**RESPONSE TO
PLANNING
OBSERVATIONS**

**PROPOSED
REDEVELOPMENT**

**10 CHRISTCHURCH
HILL, HAMPSTEAD
LONDON NW3**

November 2014

13.00 Existing
13.00 Proposed

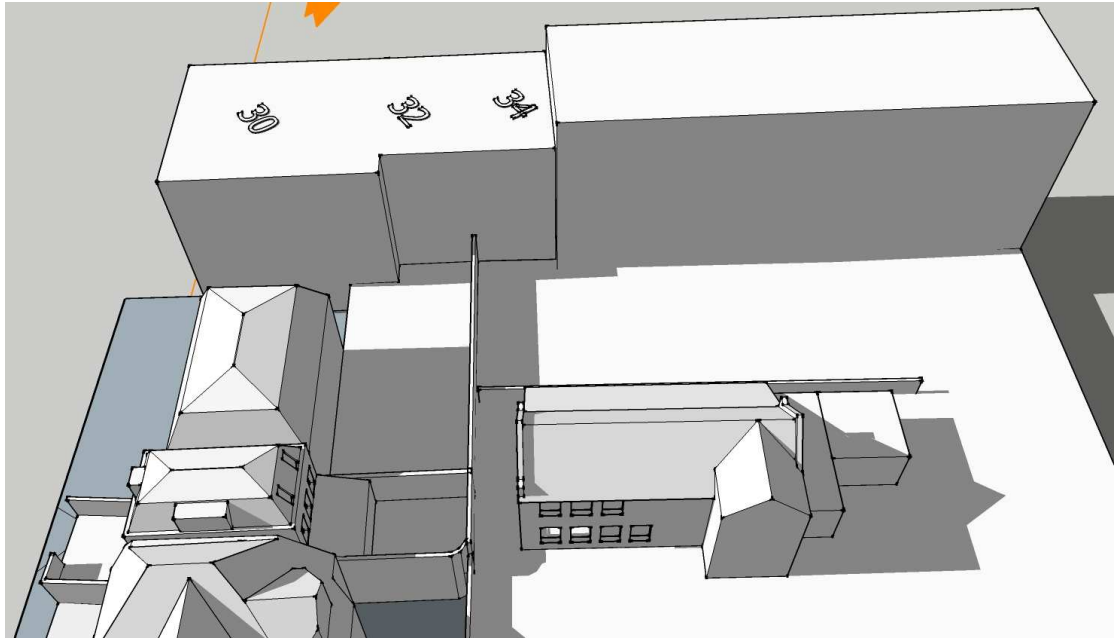
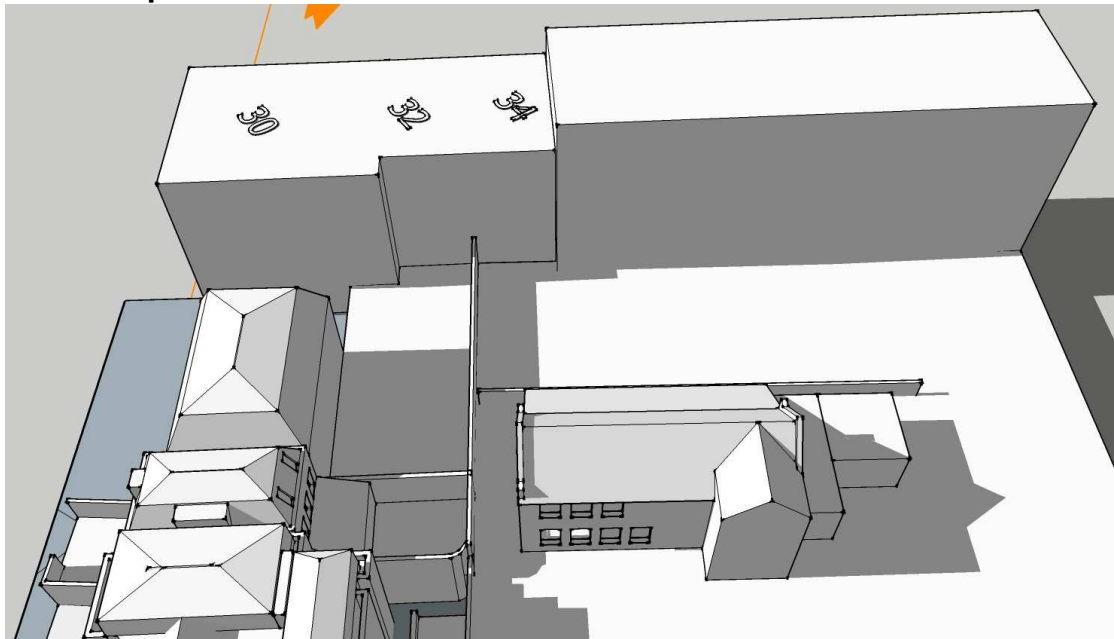
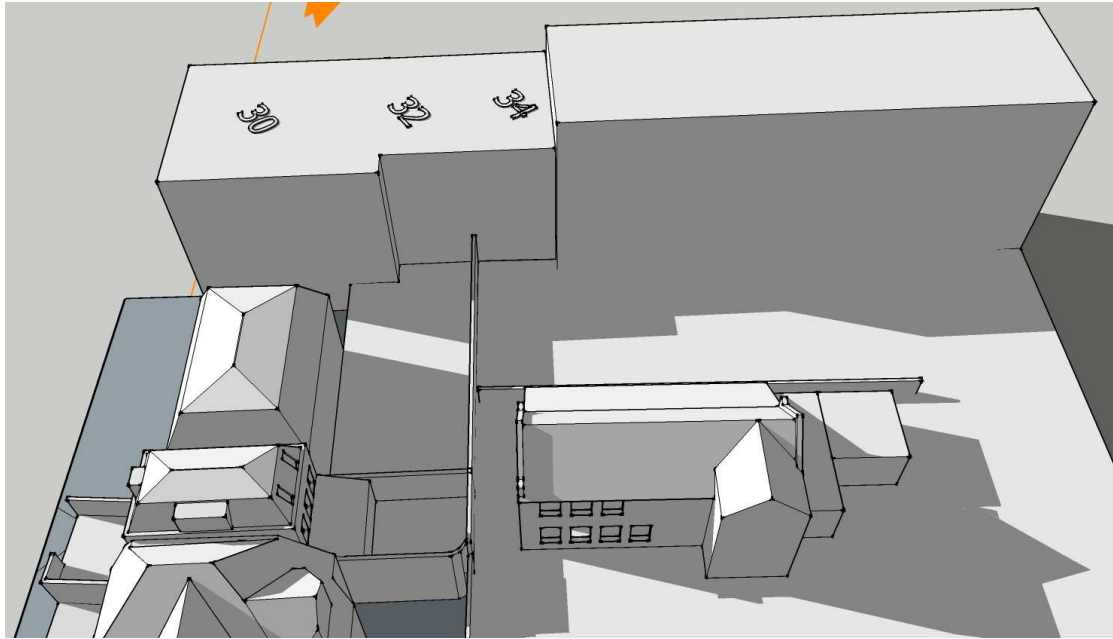
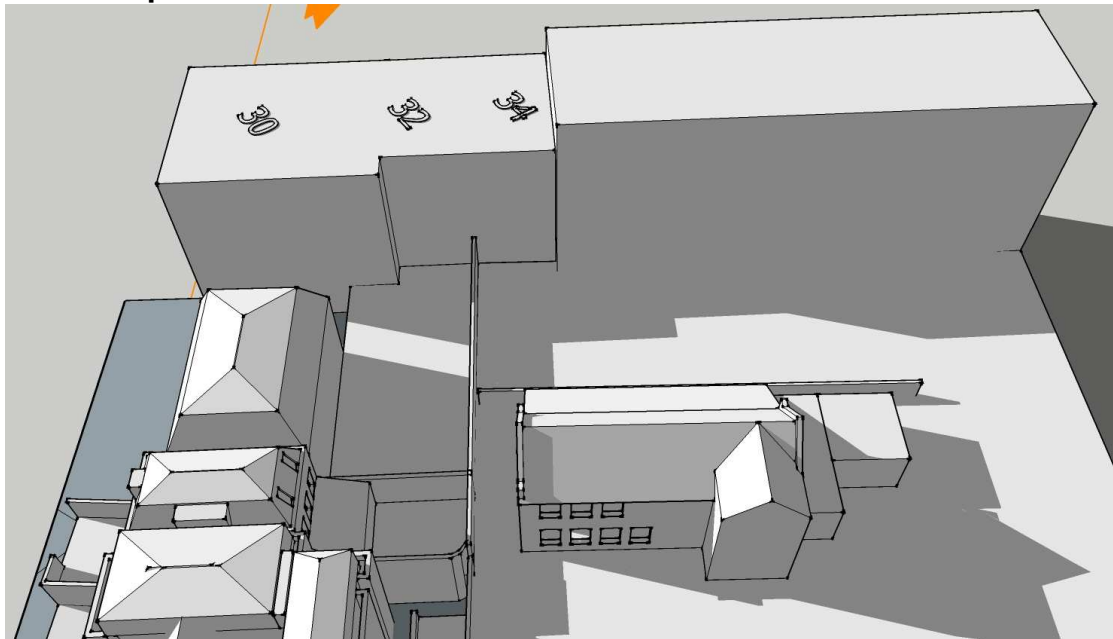
- The proposed development with its higher roofline which continues for a longer length (perpendicular to Christchurch Hill) and is also wider (parallel to Christchurch Hill), will impact the light at the back of 34 Well Walk, both in respect of the rear ground floor windows and also the patio, and will be especially acute during the Autumn to Spring months when the sun is lower and natural sun light is already somewhat limited. The Daylight & Sunlight Report submitted for this application is at a time of year which seems to drastically underestimate the effect of the proposed building given the sun is much higher in the sky in the period analysed vs. the Autumn to Spring months.
- The proposals will impact on light levels on the front gardens of nos. 13 and 14 Gainsborough Gardens and the rear gardens of 11, 12 and 13 of the same street.

As regards 34 Well Walk, it is averred that our analysis was made at an adjusted time of year to improve the apparent effects on the rear of this building and “to drastically underestimate the effect of the proposed building”. This is not the case as the initial shadow diagrams were compiled for the Equinox (21st March and 21 September). In response to this allegation, however, we have compiled proposed and existing analyses of the situation at the rear of 34 Well Walk at hourly rather than two-hourly intervals and at the Equinox, Midsummer’s Day (21st June) and Midwinter’s Day (21st December). These are set out below.

As can be seen from these images, there is no effect whatever on the sunshine reaching the rear of 34 Well Walk or its patio caused by the proposals on either Equinox nor Midwinter’s Day nor Midsummer’s Day. The assertion made is, therefore, without any foundation whatever and our original report does not underestimate the effects, drastically or otherwise, of the proposed building.
